Access Compliance Report Public Rights-of-Way (Pedestrian Signals)

Main Street: **HARBOR_BLV** Cross Street: **EDINGER_AVE** Location: **NE**

ADA ID: **SGRK220222154042** Signal Type: **One Push Button-Non APS** Overall Compliance: **No** Severity Scores: **BTN 1: 10** **BTN 2: N/A** **No BTN: N/A**

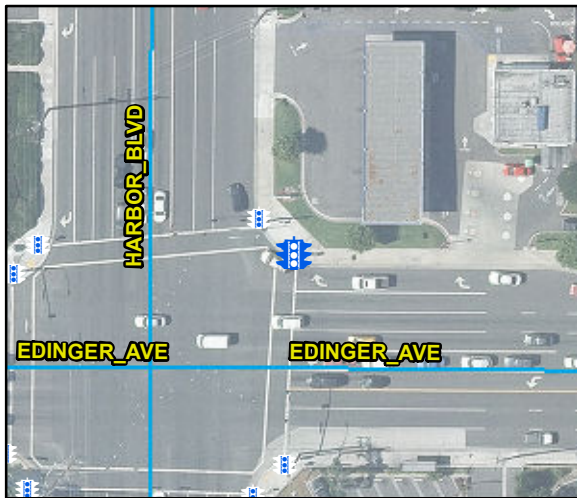
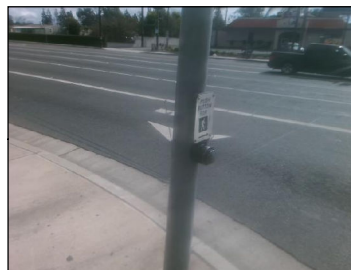
Surveyor Notes: **N/A**

OC Std/PROW: **MUTCD 4e.08**

Possible Solutions: Replace Signal Push Button With APS Button.
